CONTRACT CHANGE ORDER NO. 182
SHEET 2 OF 5

MARK	DATE	DESCRIPTIONS	BY	CH'D	CCO#
1	02/10/11	BRACKETS FOR FUTURE LIGHT PIPES	TS	JB	182

SAN FRANCISCO OAKLAND BAY BRIDGE
EAST SPAN SEISMIC SAFETY PROJECT
SELF-ANCHORED SUSPENSION BRIDGE
(SUPERSTRUCTURE & TOWER)

DETAILS
SAS SUPERSTRUCTURE GIRDER EASTBOUND
TYPICAL LIGHT PIPE INSTALLATION 1

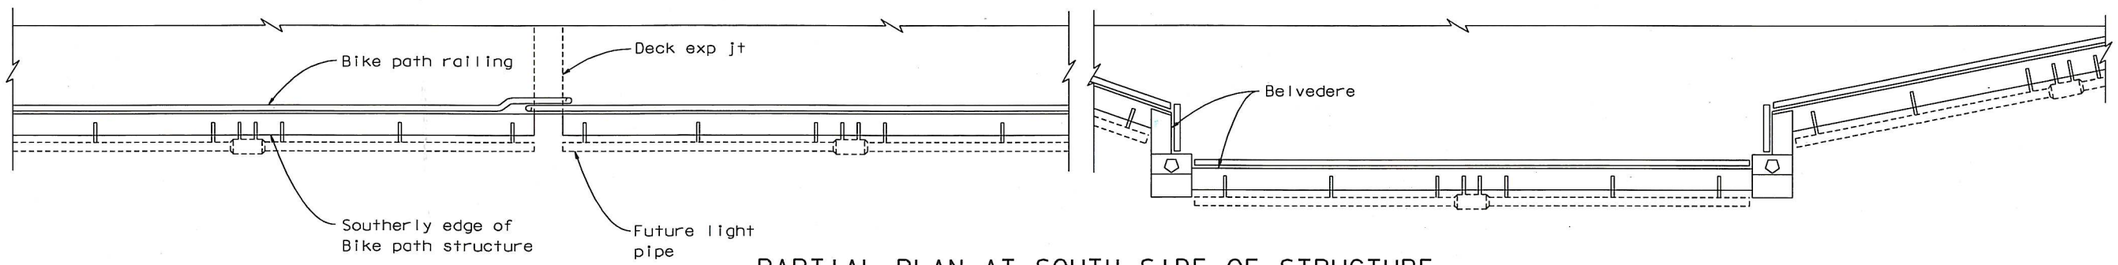
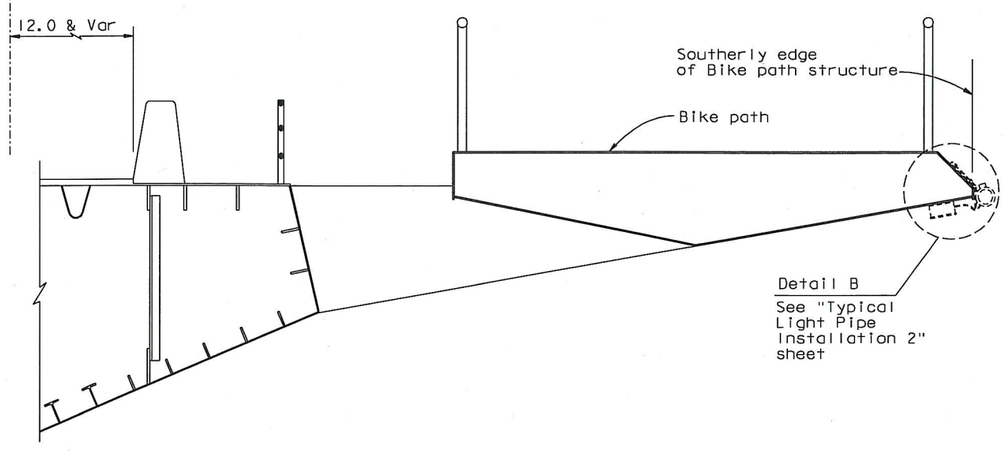
MARK	DATE	DESCRIPTIONS	BY	CH'D	CCO#
1	02/01/11	BRACKETS FOR FUTURE LIGHT PIPES	TS	JB	182

LIGHTING DETAILS NO. 2

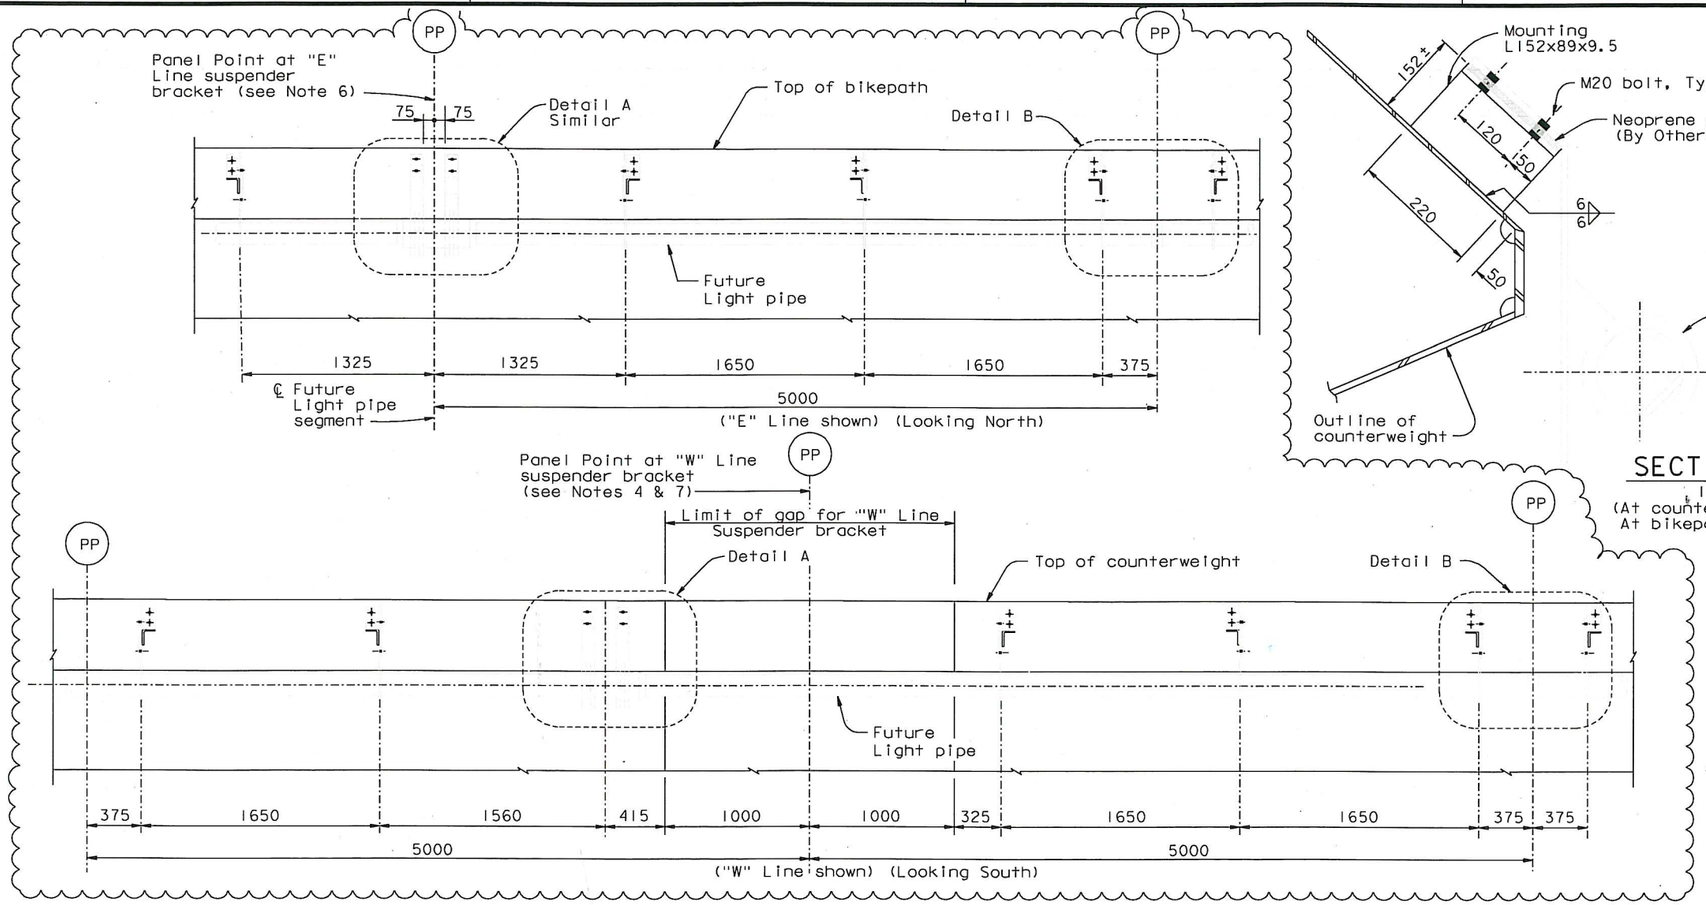
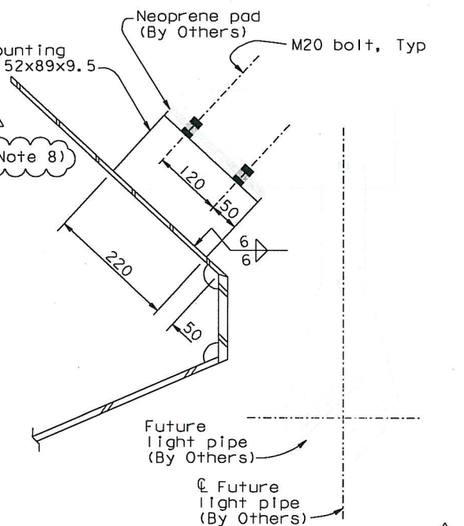
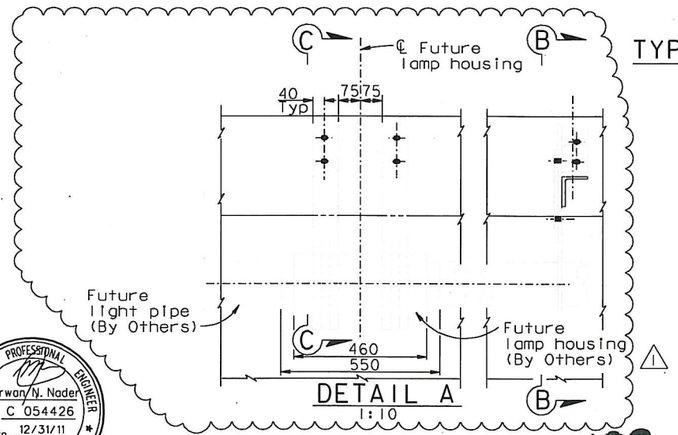
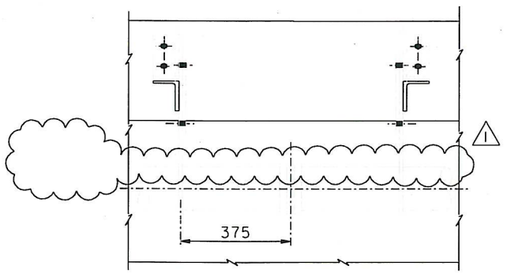
MARK	DATE	DESCRIPTIONS	BY	CH'D	CCO#
1	02/10/11	BRACKETS FOR FUTURE LIGHT PIPES	GB	MN	182

1. Details shown for counterweight side. Bikepath side similar.
2. Mounting angles shall be installed. Future light pipe and appurtenance by Others.
3. Provide all bolts to be installed in open holes.
4. Support for future light pipe is shifted to avoid counterweight gap.
5. Future light pipe support spacings are taken to the back of the mounting angles.
6. Provide future lamp housing brackets at even panel points 6 through 126.
7. Provide future lamp housing brackets at even panel points 8 through 104.
8. For mounting bracket removal procedures, see "Lighting Details No. 3" sheet.

LIGHTING DETAILS NO. 3

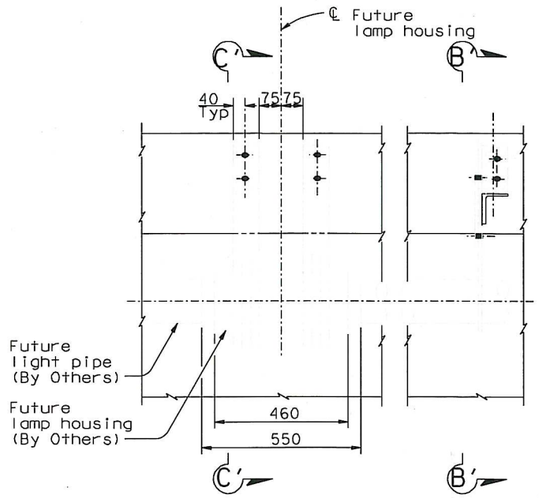
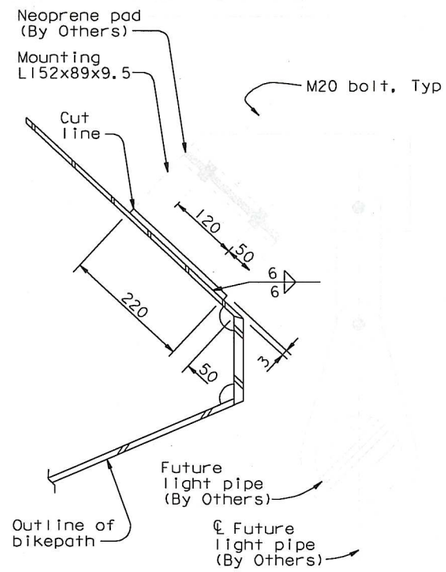
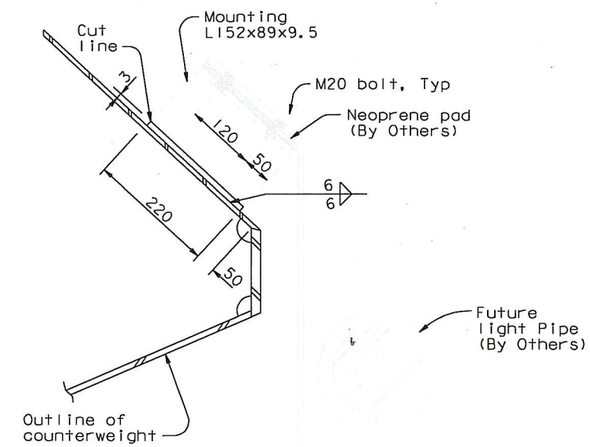
REMOVAL OF BRACKETS FOR FUTURE LIGHT PIPES

MARK	DATE	DESCRIPTIONS	BY	CH'D	CCO#
0	02/10/11	BRACKETS FOR FUTURE LIGHT PIPES	JD	MN	182

1. Cut mounting bracket a distance of 3 mm from bikepath or counterweight, or as otherwise approved by the Engineer.
2. Grind angle down flush with bikepath or counterweight.
3. Clean and paint bikepath or counterweight.
